MEMORANDUM

Re: The Royal Golf Club at Lake Elmo
Concept Plan Review

An engineering review has been completed for The Royal Golf Club at Lake Elmo (Tartan Park) Concept Plan. The submittal consisted of the following documentation prepared by Carlson McCain.

The Royal Golf Club at Lake Elmo

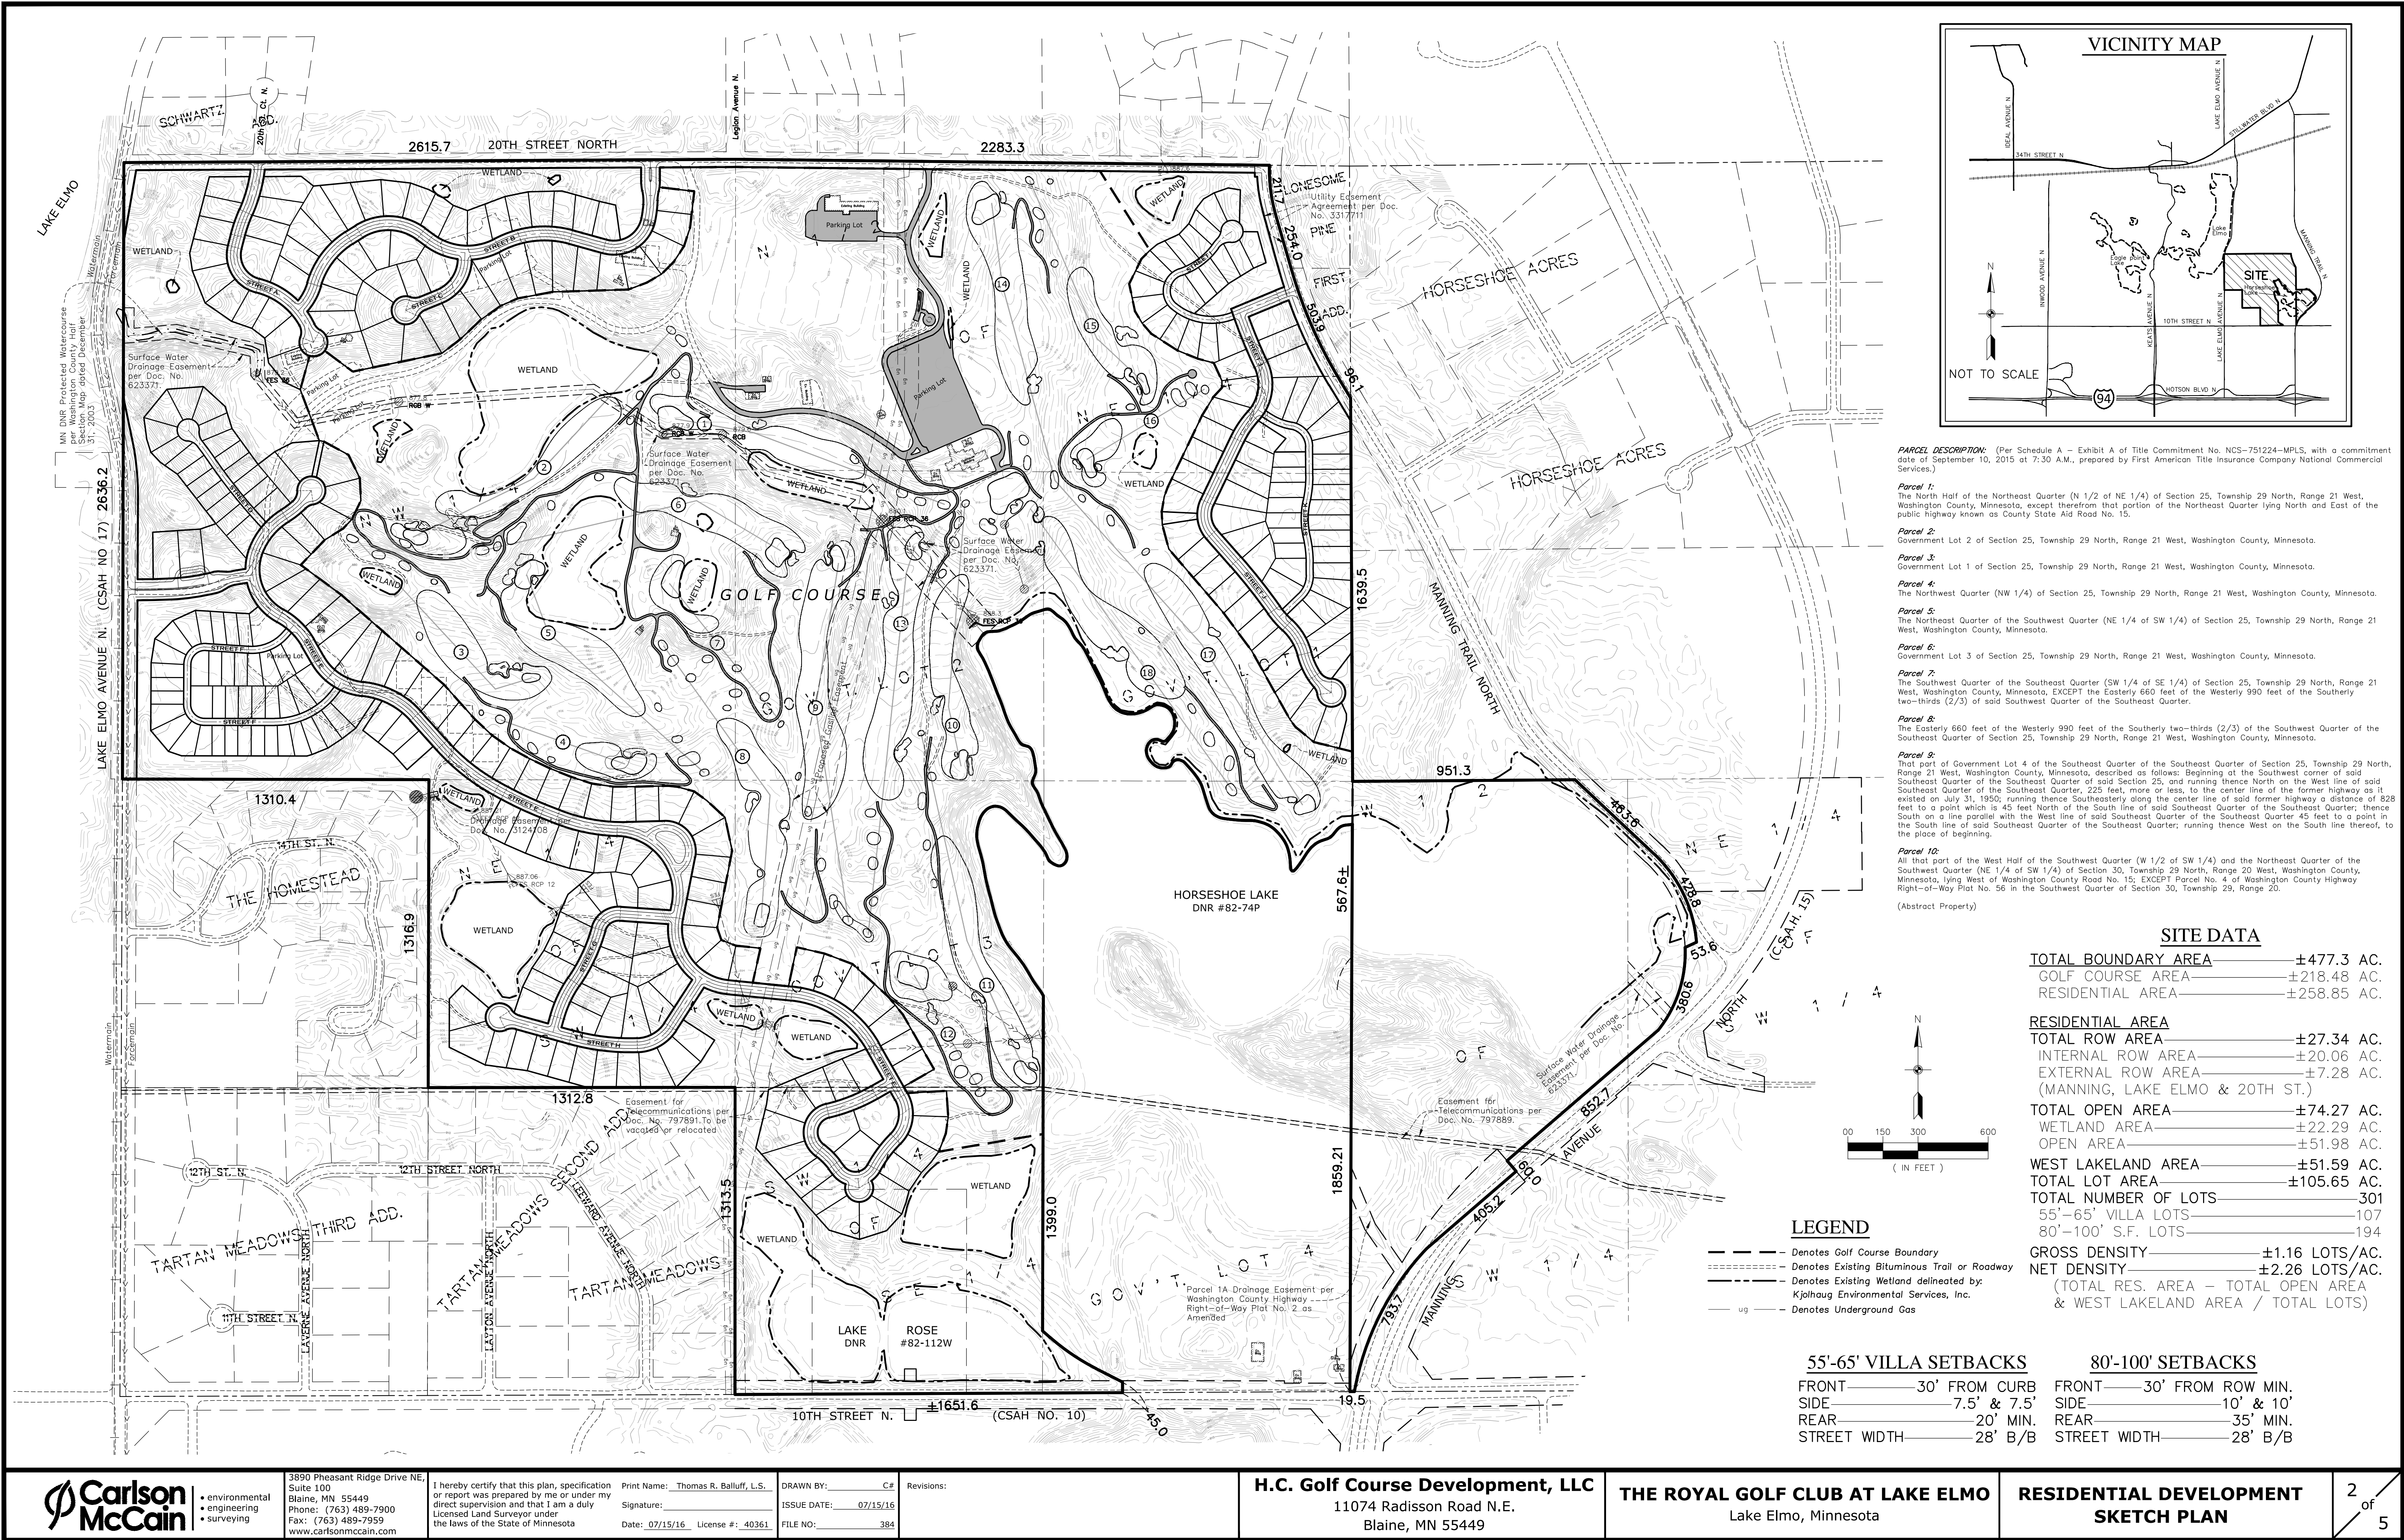
- Access Management. Access to the development is proposed in four locations accessing Lake Elmo Avenue, 20th Street North (MSA collector street), and Manning Trail North. Additional development access points are strongly recommended (see the Secondary Access and Street Interconnections bullet under RESIDENTIAL STREETS). Prior to the City receiving and accepting a preliminary plat proposal it is recommended that all development access points be reviewed and approved by the City and Washington County to verify acceptable access management spacing and adequate sight triangles for each entrance.

- The proposed access locations and considerations for the development are as follows:
 - 1) Street E access to Lake Elmo Avenue (CSAH 17). Location to be approved by Washington County.

- 2) Street A access to 20th Street North (MSA collector roadway). Access is 550 feet east of Lake Elmo Avenue vs. the required spacing of 660 feet. Proposed access location aligns with the existing intersection for 20th Street Court N.

- 3) Street B access to 20th Street North (MSA collector roadway). Proposed access is located 350 feet offset from the existing intersection of Legion Avenue. Consideration should be given to relocating this access to align with the intersection of Legion Avenue or increase the offset to 660 feet.

- 4) Street J access to Manning Trail North. Access is 550 feet south of 20th Street N. Location needs to be reviewed in the field to verify access as an acceptable location.

- Secondary Access and Street Interconnections: It is strongly recommended that additional access points and interconnections be thoroughly pursued to enhance the street network safety and accessibility. The proposed concept plan shows three separate neighborhoods all requiring direct access to a collector or County roadway without interconnection or secondary roadway connection. Area 1 proposes 170 lots with a single point of access to CSAH 17 (Lake Elmo Avenue). The 170 lots are placed along a dead end cul-de-sac over 4,500 feet long. The city standard cul-de-sac length is 600 feet while many communities have a maximum length of 1,000 feet. Area 2 proposes 57 lots with two points of access to 20th Street N. Area 3 proposes 76 lots with a single point of access to Manning Trail placed along a dead end cul-de-sac over 2,300 feet long.

- An interconnection between Street A and Street E is extremely important to provide a secondary access for Area 1 to 20th Street N., and to provide a secondary access roadway connection for Area 2 to CSAH 17. A box culvert or bridge structure should be investigated.

- The south end of Street E should be connected to 10th Street N. to eliminate a proposed cul-de-sac over 7.5 times the maximum allowed length. Staff recognizes that this connection may be difficult to make but all efforts should be pursued. If a connection cannot be physically made, any and all other emergency access options or future connection opportunities must be addressed (i.e. a trail connection to 10th Street to be used for emergency and future roadway construction purposes, right-of-way dedication to the edge of the plat for a future roadway connection, loop the south end of Street E to connect to Street H, etc).

- Street J should be align to connect to both 20th Street N. and Manning Trail to provide access to two separate collector roadways. If this is found to be unfeasible then two connections to Manning Trail should be made to eliminate the long dead end cul-de-sac.

- Private owned HOA streets have been proposed in areas of this development including Streets D, F, I and K. Privately owned HOA streets should not be allowed. Typically private streets are proposed for the purpose of decreasing street and boulevard design standards including setbacks for the structures. The City design standards have been established as "minimums" for the purpose of serving as public access, drainage, sanitary sewer, and municipal water service. The boulevard corridor also provides a dedicated location for small utilities such as gas, electric, cable, telephone and fiber optics. Reducing the R/W width

- Parkway or divided roadways must be a minimum of 18 feet wide from back or curb to back of curb. The development street plan indicates landscaped medians at two of the development entrance points.

- The grading plan indicates significant use of retaining walls. Retaining walls should be placed within private lots or Outlots to be owned and maintained by the HOA. Retaining walls should be placed on City R/W or Outlots dedicated to the City. Retaining walls should also not be placed within lot drainage and utility easements.
